Access Compliance Report

Public Rights-of-Way

(Curb Ramps)

Intersection ID: 50609	Main Street: DOWNY_BIRCH_RD	Cross Street: PADDLE_OAK_RD	Location: SE
ADA ID: C52C58624A7E	Ramp Type: Perp	Initial Pass/Fail: Pass	Overall Compliance: No
Severity Score: 0			
Codes/Mitigation Info/Possible Solution		Field Measurements/Component Compliance

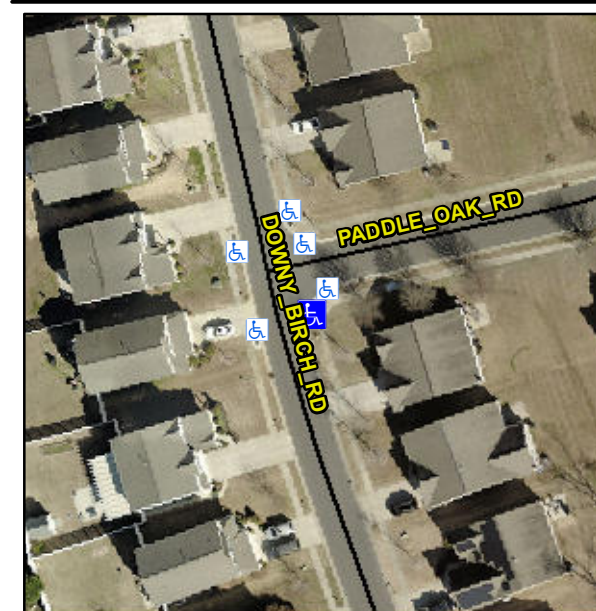
Not Found, R304.2.1, R304.2.2-Perp, R304.3.2-Para, R304.5.3, R305.2

Compliance	Description	Data	Compliance	Description	Data
N/A	Ramp Length (in)	48.0	Yes	Ramp Slope (%)	6.1
Yes	Ramp Width (in)	48.0	Yes	Ramp XSlope (%)	1.9
N/A	Flare Type LT	Sloped	N/A	Flare Type RT	N/A
N/A	Flare Slope LT (%)	10.4	N/A	Flare Slope RT (%)	4.9
N/A	Flare Traversable LT?	No	N/A	Flare Traversable RT?	No
No	Landing Length (in)	47.0	Yes	DWS Provided?	Yes
Yes	Landing Width (in)	54.5	Yes	DWS Contrast?	Yes
No	Landing Slope (%)	4.6	Yes	DWS Length (in)	24.5
No	Landing X Slope (%)	3.1	Yes	DWS Full Width?	Yes
N/A	Landing Curb? (Y/N)	No	No	DWS Offset (in)	6.5
N/A	Shared Landing?	Yes			
Yes	Gutter Ponding?	No	Yes	Gutter Slope (%)	4.4
Yes	Gutter Lip Ht (in)	0.0	Yes	Gutter X Slope (%)	2.0
N/A	Painted X Walk1?	No	N/A	Painted X Walk2?	N/A
	X Walk 1 Direction	To W		X Walk 2 Direction	N/A
N/A	X Walk 1 Width (in)	N/A	N/A	X Walk 2 Width (in)	N/A
	X Walk 1 Slope (%)	0.5		X Walk 2 Slope (%)	N/A
	X Walk 1 X Slope (%)	0.8		X Walk 2 X Slope (%)	N/A

N/A	Ramp inside XWalk1?	N/A	N/A	Ramp inside XWalk2?	N/A
	Road Slope (%)	N/A	N/A	Clear Space?	Yes
	Road X Slope (%)	N/A	N/A	Clear Space to XWalk (in)	N/A
Yes	Any Obstructions?	No	Yes	Storm Grate/Utility Hazard?	No
	Obstruction Type			Storm Grate/Utility Type	
		N/A			N/A
			Yes	Surface Condition? (G/P)	Good

Remove & Replace Entire Ramp.
